Date: Nov. 3, 2020
Project: MDUSD – Food & Nutrition Services
Concord, CA

Re: Proposal for Extra Work – M & O Site Paving

Re: Proposal for Extra Work – M & O Site Paving – C O # ⁴ ~~8~~ – Trench Drain *WJ*

Re: Proposal for Extra Work – M & O Site Paving – C O # 5 – Remove and Replace additional asphalt in front of Loading Dock, Replace Christy Box

Add Alternate #002: Remove and Replace Concrete at Loading Dock

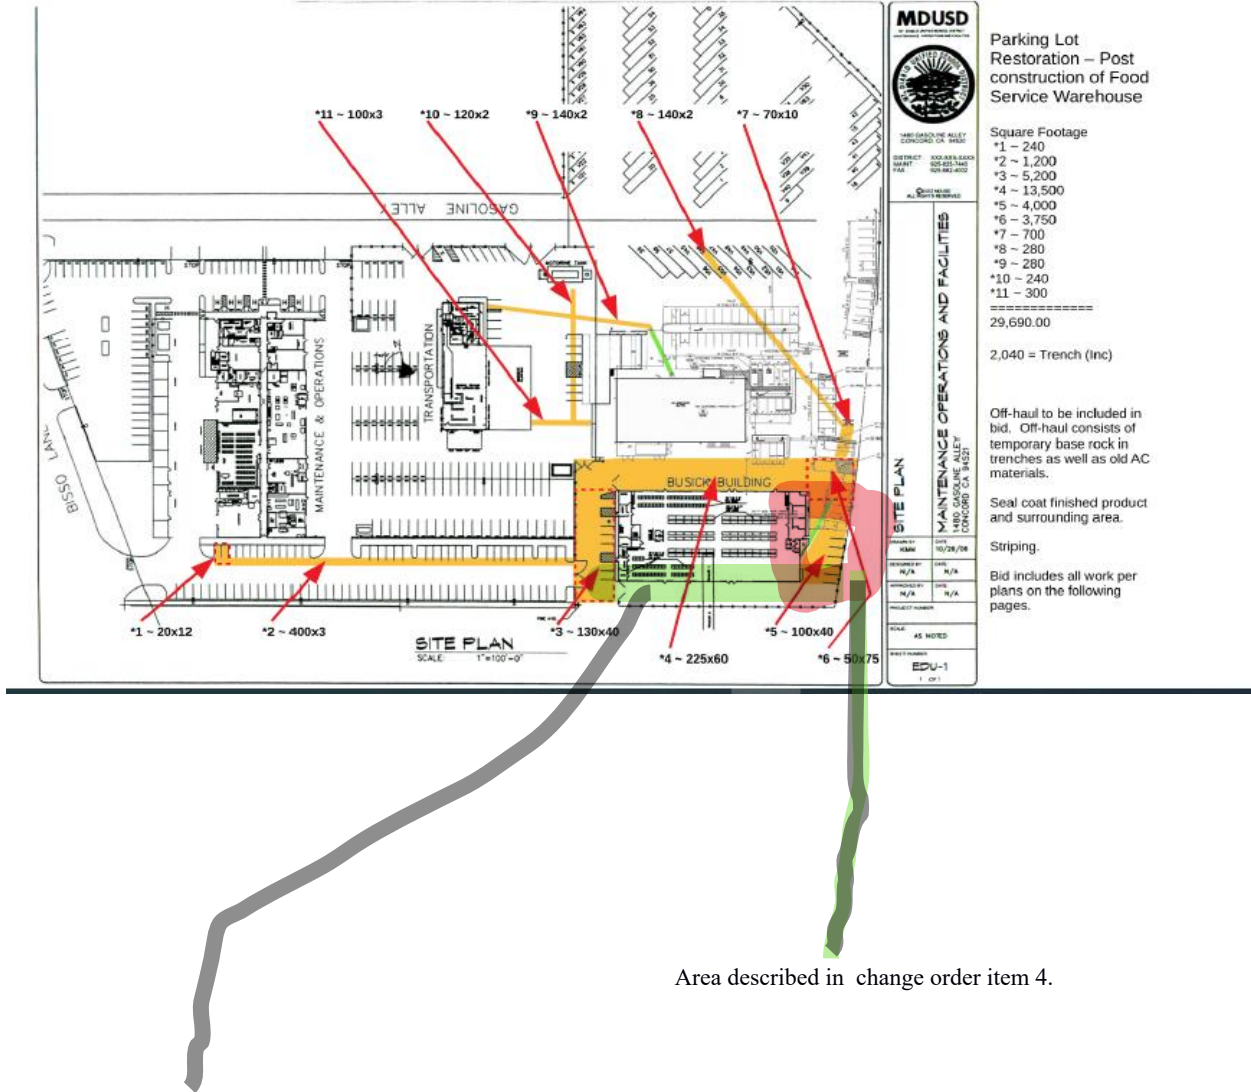
New Concrete to be 6" Flatwork with #4 Rebar at 18" O.C.E.W

SHEET NUMBER: C2.01

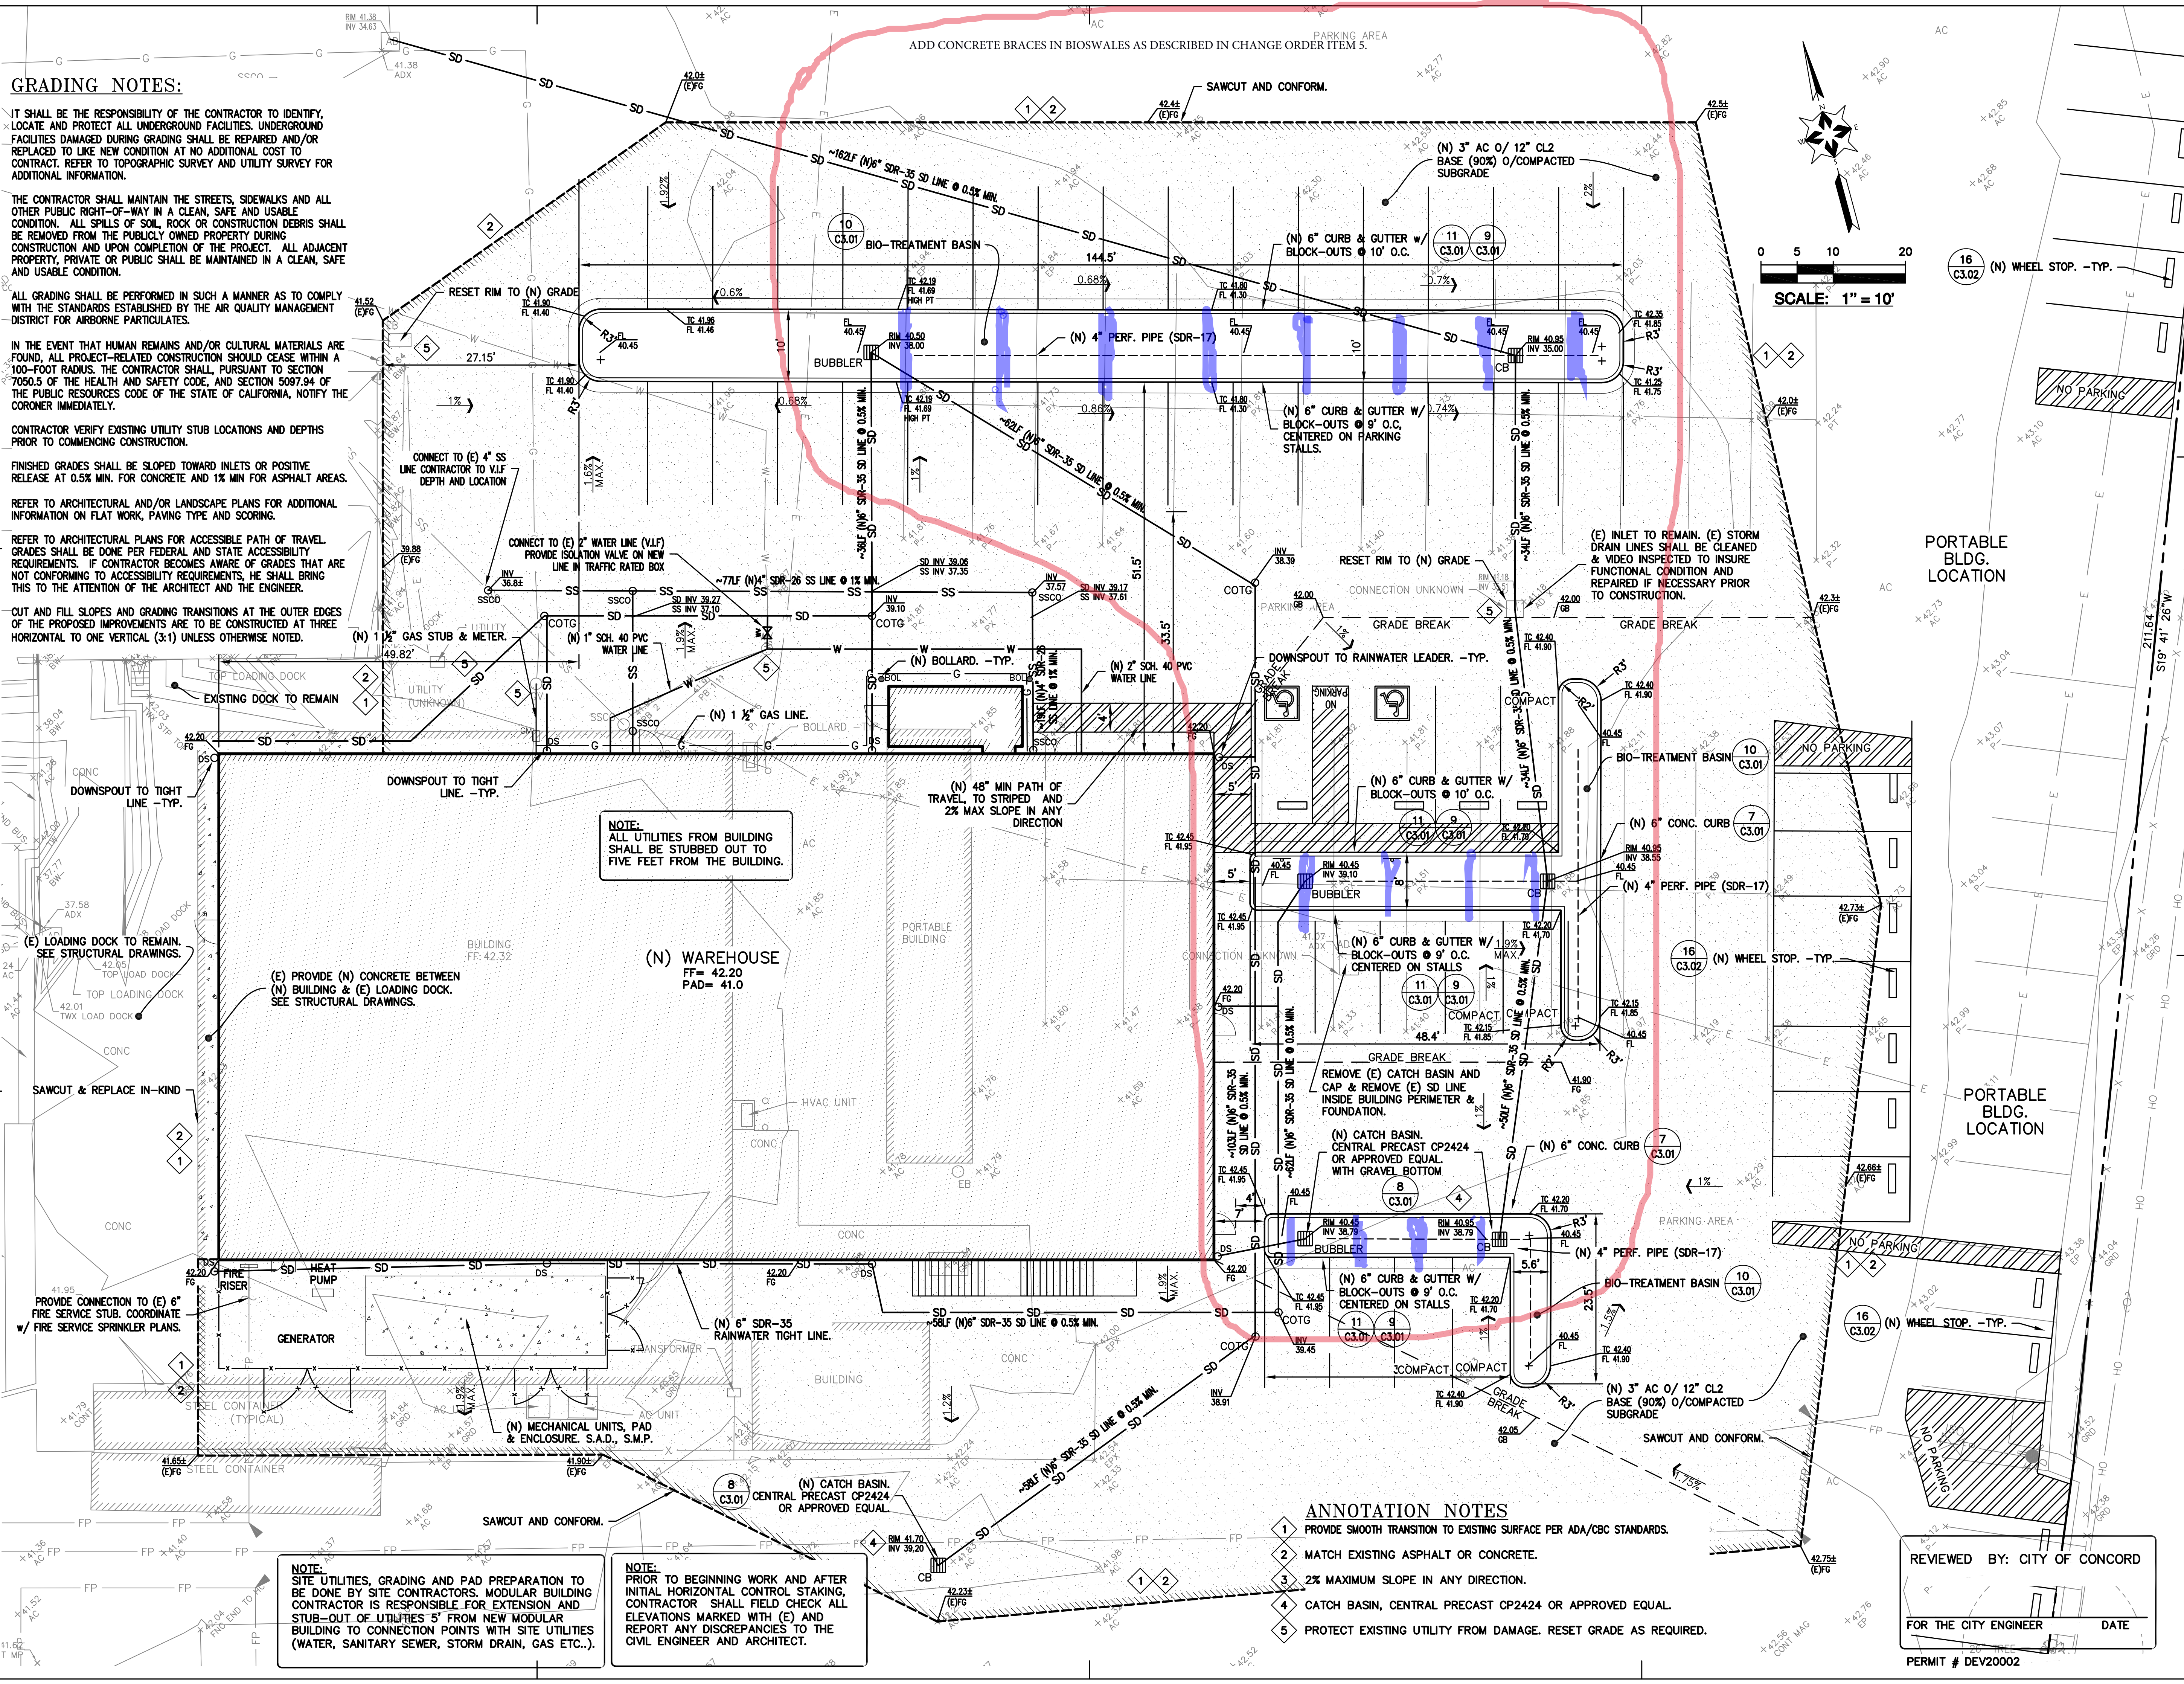
1. Addition asphalt at the west end of the new loading dock slab: **\$7,332.00**

This area is not in the original contract. We propose placing a 6" deep lift asphalt section approximately 43' x 21'. Price includes demolition, subgrade prep., baserock as required to smoothly transition to the adjacent property.

4. Credit for change in scope in the area that is part of alt. 1: **-\$9,700.00**

This is the area on the east end of the existing building (alt. 1 area 5), 4,000 SF. This would be done at the same time and in the same manner of the work described in item 3 above, meaning we would mill off 4 inches of material, compact the existing base material, and install a new pavement section of asphalt 4" thick, to be done in two lifts. The credit is for not having to excavate to the full depth baserock section and import new baserock.

Area described in change order item 1.

Area described in change order item 4.

Area described in change order item 2 (asphalt) and item 3 (valley gutter)

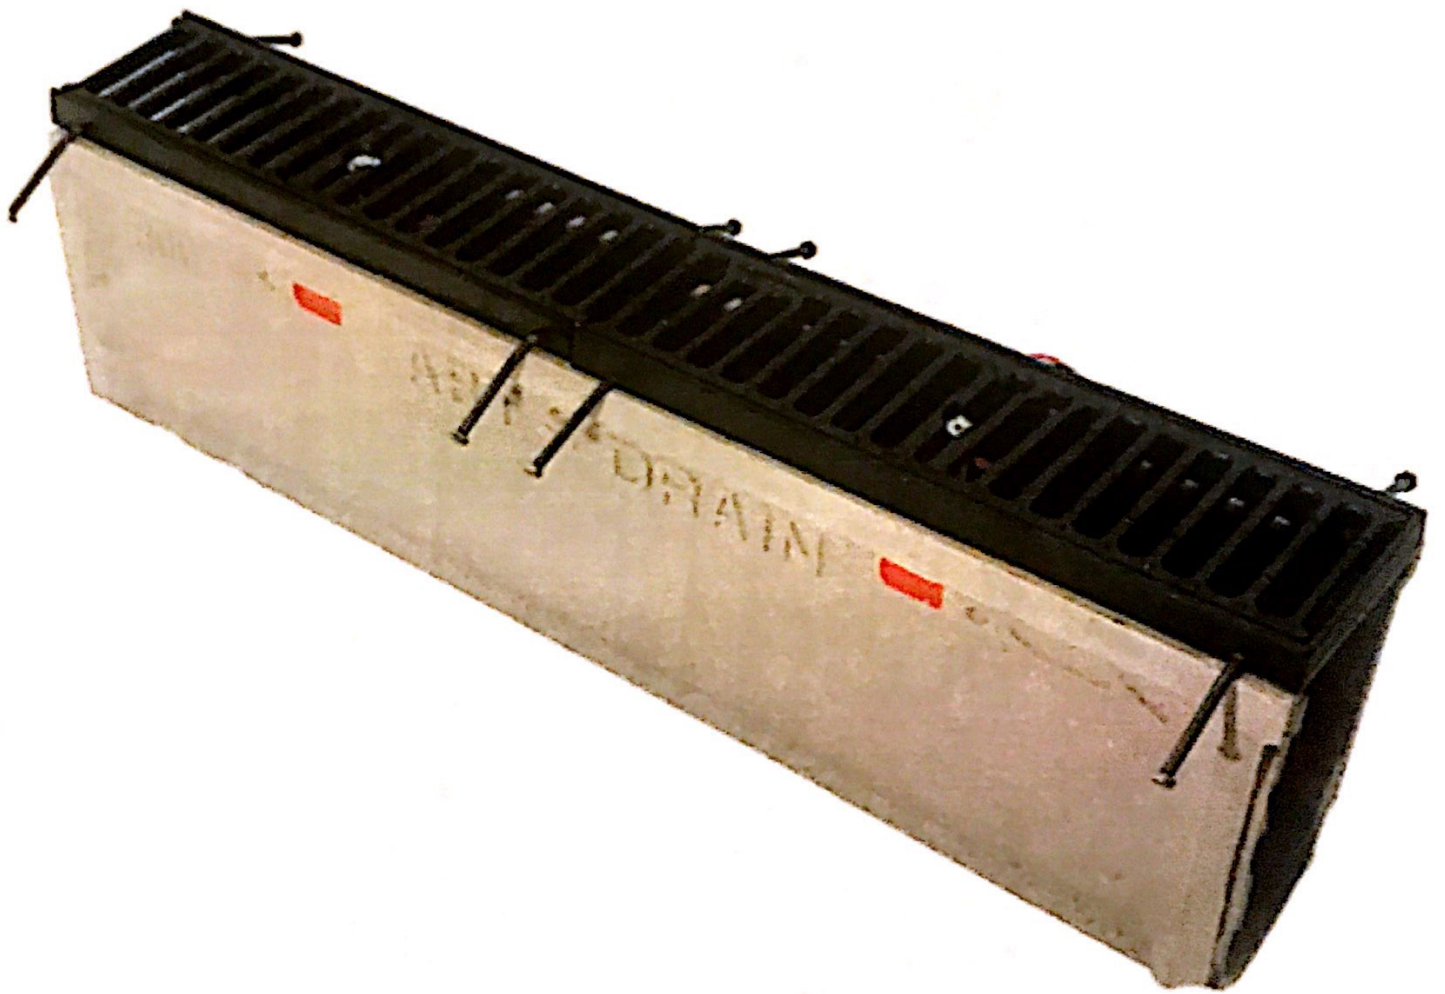
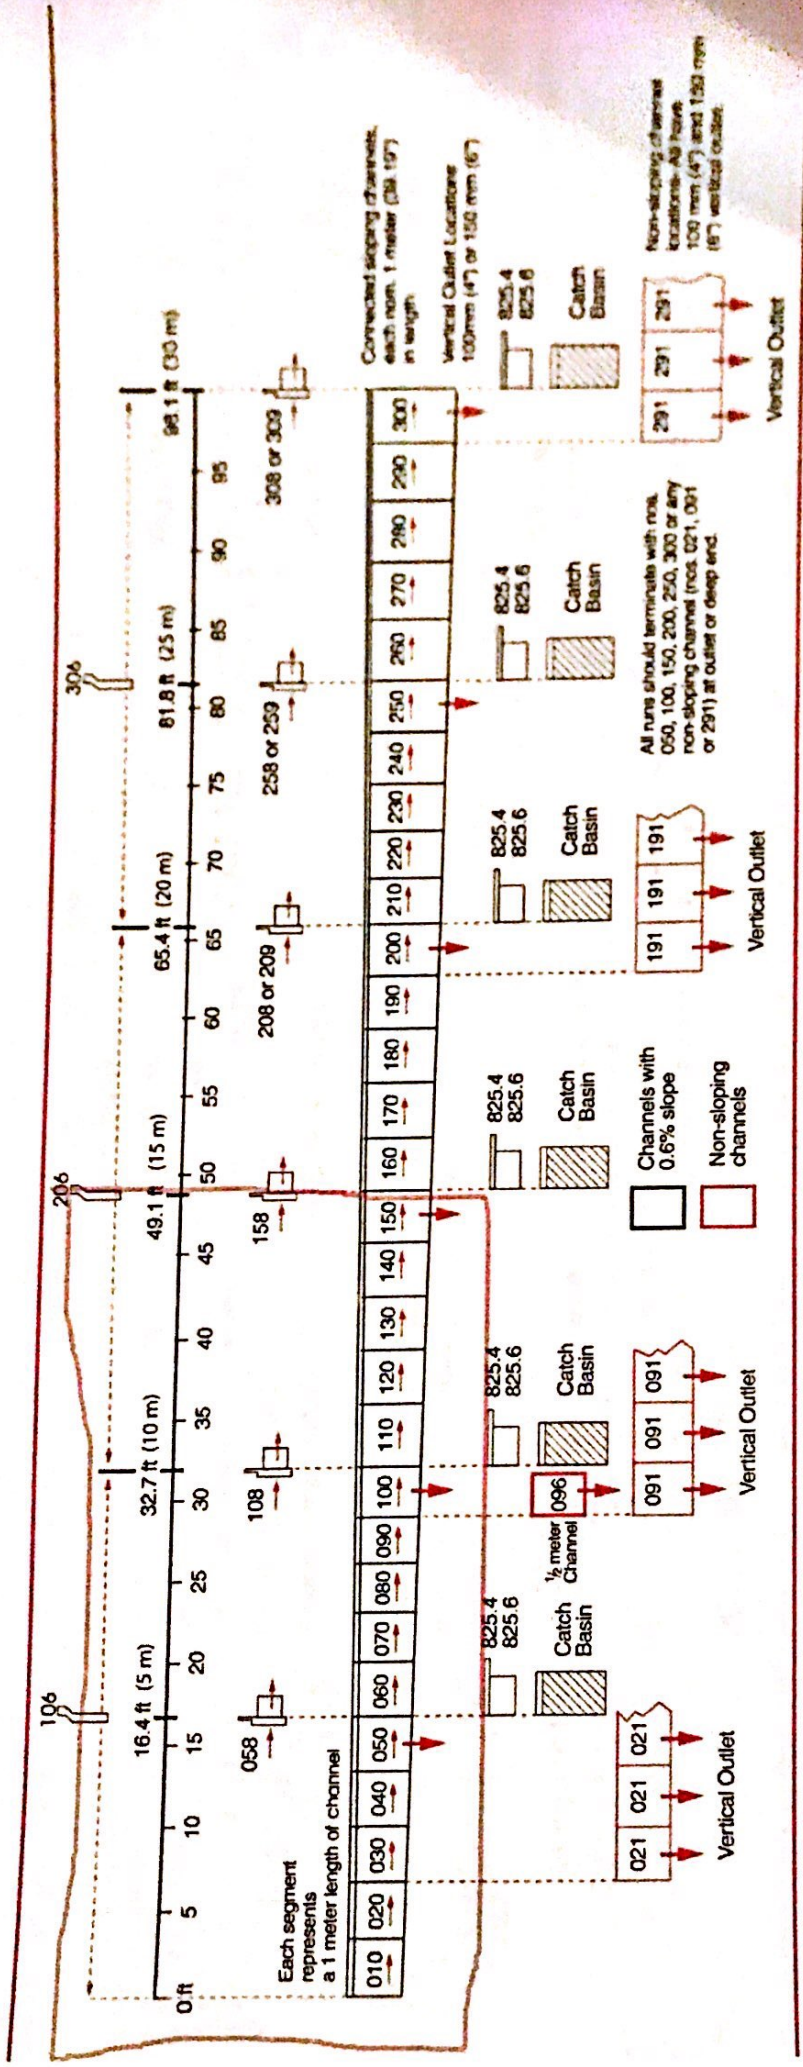
Supply and install Polydrain Trench Drain System at edge of existing generator slab. Price includes excavation, tie into storm drain system, form and pour concrete band to contain trench drain.
